GROUP 21
CLUTCH

OUTLINE OF CHANGES

- Service point for the clutch pedal installation has been added.
- Service procedures for the clutch control have been changed since the clutch fluid line routing has been changed.
  <L.H. drive vehicles>

CLUTCH PEDAL AND PEDAL SUPPORT MEMBER INSTALLATION

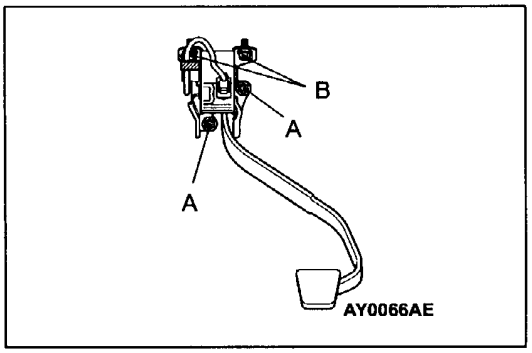
Tighten the clutch master cylinder mounting nuts (A), and then the clutch pedal mounting bolts (B).

NOTE
The pedal support member can not be positioned correctly if the pedal mounting bolts (B) are tightened first as the their holes are oblong holes.
